Commission Meeting Date: December 4, 2008

PLANNING COMMISSION AGENDA ITEM

CITY OF SHORELINE, WASHINGTON

| Study Session on Development Code Amendments, Application #301543 |

Figure 20.50.440(C): Illustration of desired bicycle facility location.

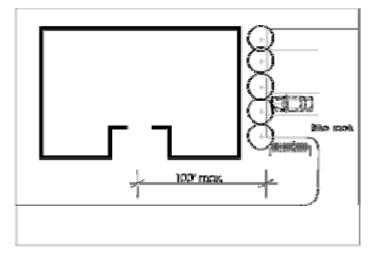
<u>D</u>. C. All bicycle parking and storage facilities shall be located within 100 feet of the building entrance and shall be located in safe, visible areas that do not impede pedestrian or vehicle traffic flow, and shall be well lit for nighttime use.
